## **Development Services Staff Report**

File Number PL2024-135

File Name PRELIMINARY DEVELOPMENT PLAN – QuikTrip

Property Address 1001 and 1005 SW Blue Pkwy

Figure 2 – Existing curb line shown in red. Proposed curb line shown in blue. Proposed parking setback reduction area shaded orange.

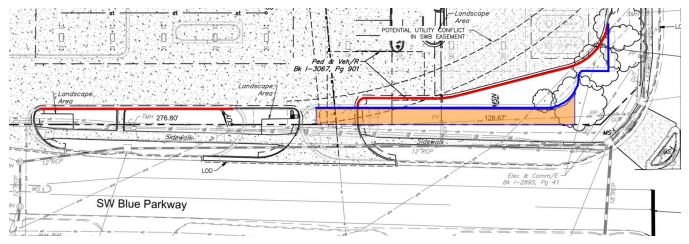
Parking Lot Setback (UDO Section 8.620.B.1). Modification requested. Staff supports modification request.

- Required minimum 20' setback from the right-of-way
- Proposed 10' setback from the right-of-way

As previously stated, the majority of the existing parking lot boundaries along the two SW Blue Pkwy street frontages will be retained. However, there is one area near the northeast corner of the site where the applicant proposes to push the parking lot boundary closer to the right-of-way. More specifically, the applicant proposes to reduce the parking lot setback along the east frontage of the former car wash site from the existing 16' to 10'. The reduced setback will match the existing 10' parking lot setback that will be retained along the east frontage of the existing QuikTrip (see image below). The reduced setback also creates more room to accommodate the location of new parking spaces at the northeast corner of the site, plus creates more room to accommodate adequate circulation around the northeast corner of the pump island canopy. Staff supports the modification request.

- 1. Development shall be in accordance with the preliminary development plan received July 8, 2024.
- 2. A modification to the minimum 20' parking lot setback requirement from the public right-of-way shall be granted, to allow a 10' parking lot setback along the east parking lot boundary fronting SW Blue Pkwy as depicted on the preliminary development plan received July 8, 2024.
- 3. A modification to the requirement for straight-back (CG-1) curbing along all parking lot and driveway boundaries shall be granted, to allow roll-back (CG-2) curbing at the three driveway entrances and the ends of landscape areas abutting parking lot drive aisles as depicted on the preliminary development plan

Figure 3 - Roll-back curb locations clouded in red.

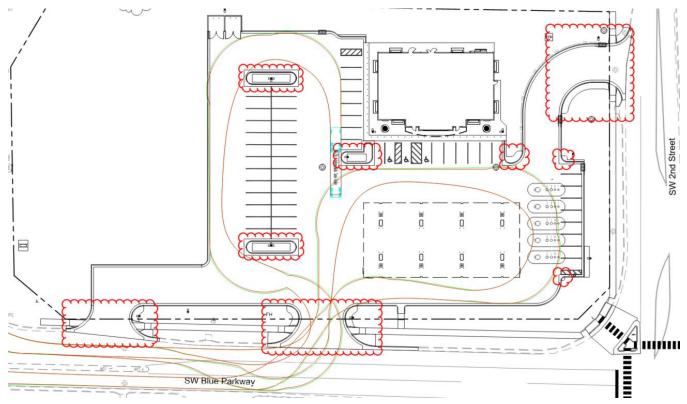
#### Parking Lot Curbing (UDO Section 8.620.F.2). Modification requested. Staff supports modification request.

- Required all vehicle parking lot areas and access drives in all zoning districts shall have a boundary constructed of straight-back Portland cement curbing (CG-1) or an integral Portland cement concrete sidewalk and curb with vertical face
- Proposed mountable roll-back curbing (CG-2) is proposed at all three driveways and the ends of all landscape islands/areas adjacent to a drive aisle

• Recommended – QuikTrip prefers to use roll over curbs on any radius inclined to be run over by a vehicle. This is meant to prevent repeated damage and repair to the curb and landscaping. With daily gas deliveries and warehouse deliveries via large vehicles with larger turning radii, the roll over curbs at the driveway entrances help sustain the parking lot's lifespan. Additionally, the islands shown by the floating parks around the building see a lot of customer traffic that includes the use of larger commercial vehicles. Allowing roll over curbs on the select locations shown on the plans help prevent the wear and tear of the parking lot areas and grass and thereby help maintain a clean and desirable look. The use of roll over curbs was approved for similar areas at the NE Woods Chapel Rd, NE Mulberry St and SW M-150 Hwy QuikTrip locations. Staff supports the modification request.
